STATE OF WASHINGTON
DEPARTMENT OF ECOLOGY

Re: Completion of *Hanford Federal Facility Agreement and Consent Order* (Tri-Party Agreement)
Target Milestone M-083-24-T01, "Submit Revision 0 of the PFP Complex Surveillance and
Maintenance (S&M) Plan to Ecology," due June 30, 2016

Review Comment Record

Draft DOE/RL-2011-59, Decisional Draft C-1

Figure 1. Slabs and Underground Structures in S&M Area

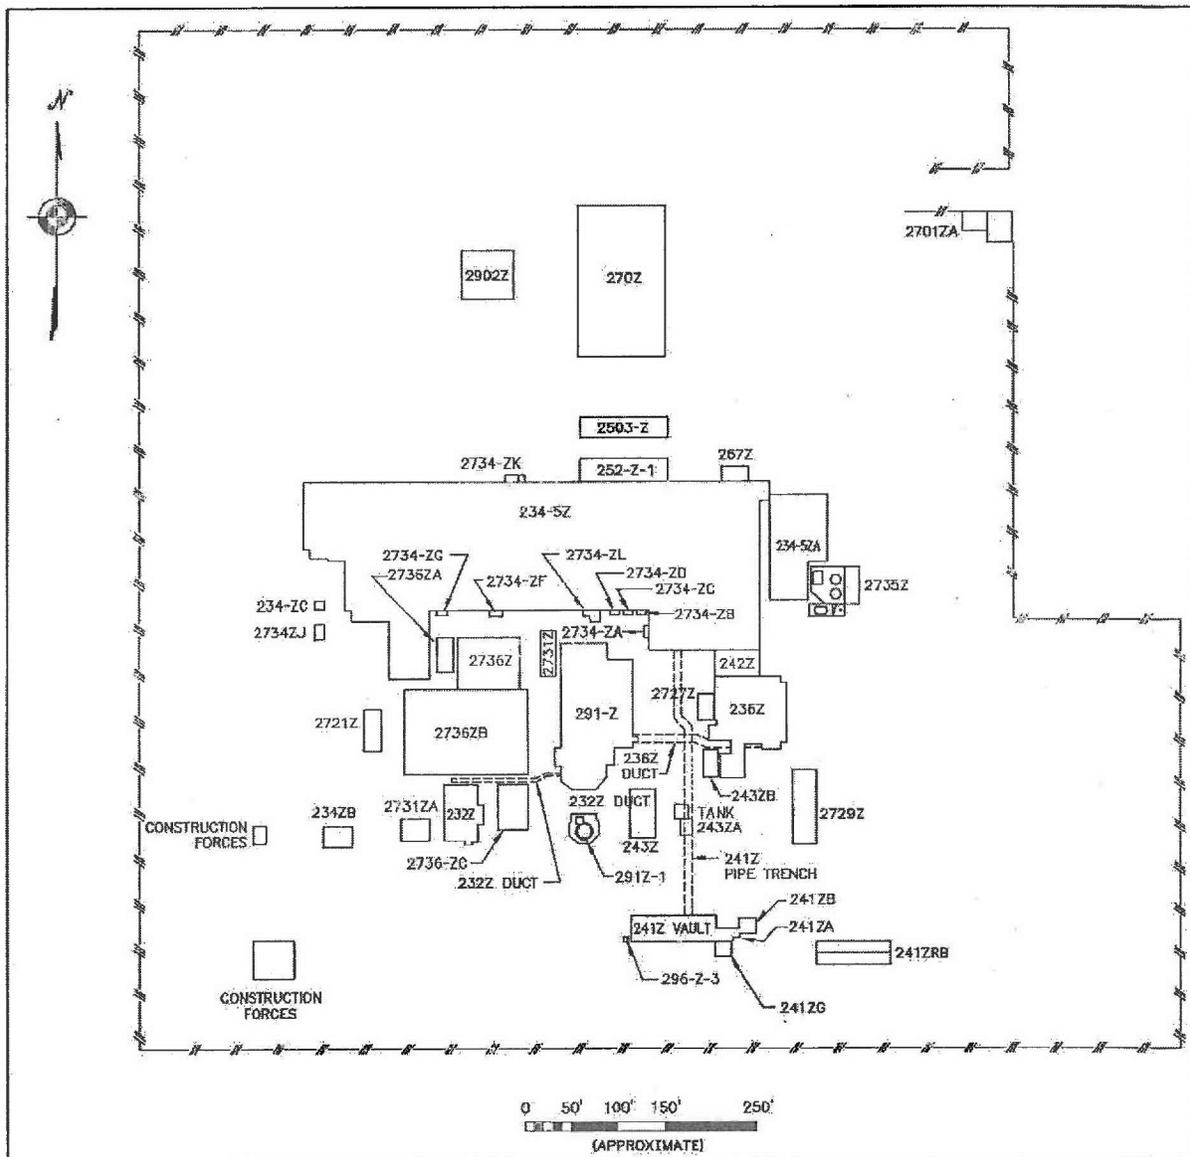
11	Pg. 4, Figure 1	There are slabs on Figure 2 that aren't on Figure 1. Also how do the fenced areas between Figures 1 and 2 compare? Are both defining the scope of the S&M?	Please clarify.		Figure 1 will be removed and figure 2 will be updated to show only appropriate inside the fence items.	Accept	Close	SS
12	Pg. 5, Lines 1-21	Rev. B of the S&M plan included "Storm water runoff that currently drains to the Treated Effluent Disposal Facility (TEDF) may continue being collected and drained to TEDF during S&M." This is not in Rev. C.	Is this still relevant? Why or why not? Please revise accordingly.	Clarification.	The decision has been made to terminate all discharges into the TEDF system. Therefore, this option was removed from Draft C. Suggest no changes be made to this section.	Accept	Close	SS
13	Pgs. 5-6, multiple line items that were deleted.	Why were these bullets deleted?	Please clarify.		Repetitive bullets were combined and non-significant actions deleted. This is not intended to be an exhaustive list. Added the following bullet back in: Provide controls to prevent unauthorized access.	Accept	Close	SS

17	Pg. 7, Table 1	Entry for Gas Bottle Storage. Identification 2734-ZA, -ZB, through -ZK	Are these slabs notated on Figure 2? They could not be found on the Figure.	Clarification.	They will be added to the new figure 1.	Accept	Close	SS
18	Pg. 8, Section 2.2, Line 8	"Information about other buildings that should be noted are provided..." Are these buildings in Figure 2?	Clarify in this statement that these "other buildings" are listed on Table 2.		This sentence was rewritten as follows: The following subsections provide information about the major underground structures from Table 2.	Accept	Close	SS
19	Pg. 8, Section 2.2, Line 16	To be consistent with other redlines, "clean" backfill is referenced here, but deleted in other sections.	Suggest deleting "clean" if appropriate, to be consistent.		Removed the word "clean".	Accept	Close	SS
20	Pg. 8, Section 2.2.1	Is there a Figure that could be included to show the relationship between the tunnels and trenches? With the two separate figures it is hard to understand the relationship between the two.	Suggest including a Figure denoting the relationship (trenches that connect to the tunnels) between the tunnels and trenches in 234-5.	Clarification.	A new figure will be developed to replace both existing -5 figures that demonstrate this relationship.	Accept	Close	SS
